**DESIGNER'S RESPONSE TO ROAD
SAFETY AUDIT STAGE 1**

HAMPTON QUAY, LITTLEHAMPTON, WEST SUSSEX, BN17 5RA

**DESIGNER'S RESPONSE TO ROAD SAFETY AUDIT STAGE 1
ON BEHALF OF STOLON STUDIOS LTD**

Report No.: 18-270-04D

PROPOSED OFFSITE IMPROVEMENTS &
ALLOWANCE FOR FUTURE IMPROVEMENTS

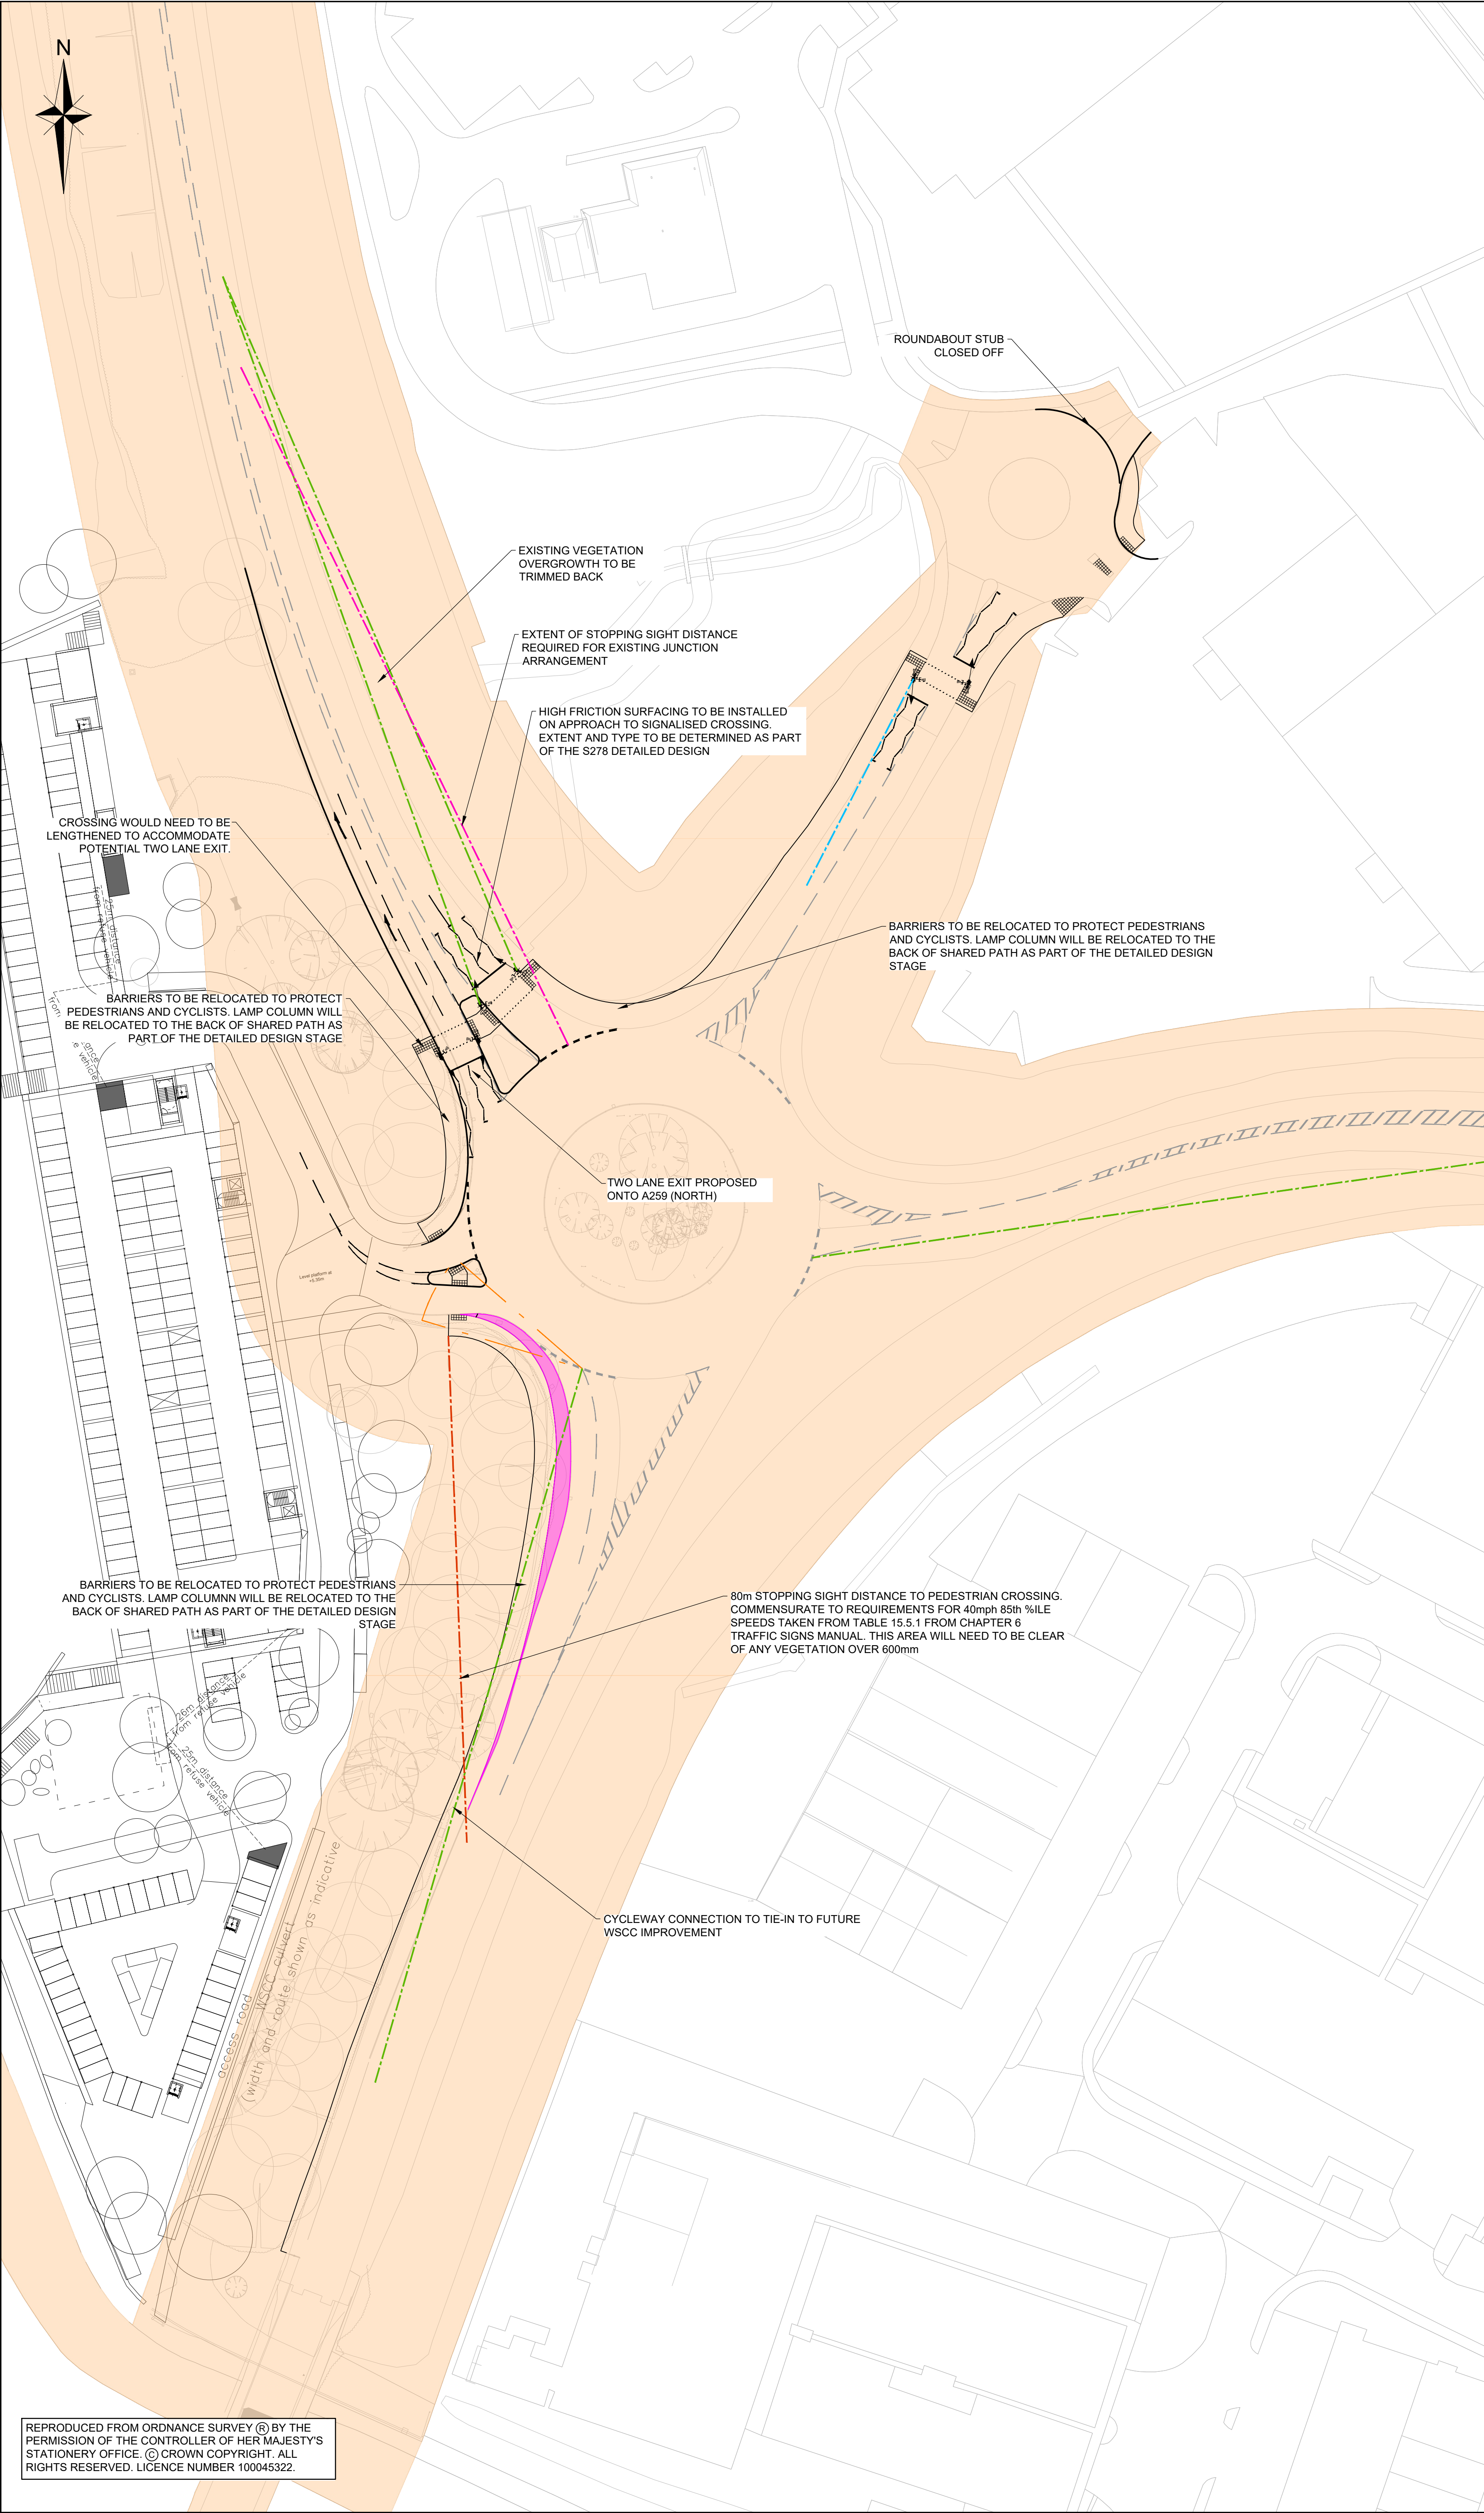
3.2.2	PROBLEM Location: Bridge Road Roundabout – pedestrian crossing point on proposed arm.	It is recommended that the SSD to the crossing should be free from obstruction and provided for assessment.	Drawing 18-270/010 has been revised to show visibility requirements to the pedestrian crossing as per Figure 3.53 in

3.5.2	PROBLEM Location: Northern exit to the roundabout.	It is recommended that the merge length should be extended, and separation should exist between the entry and exits lanes with measures	Drawing 18-270/010 has been updated to Revision F, refer attached, to show the length of merge extended. This revised

VISIBILITY TO PEDESTRIAN CROSSING
(DRAWN IN ACCORDANCE WITH FIGURE 3.53 OF CD116)
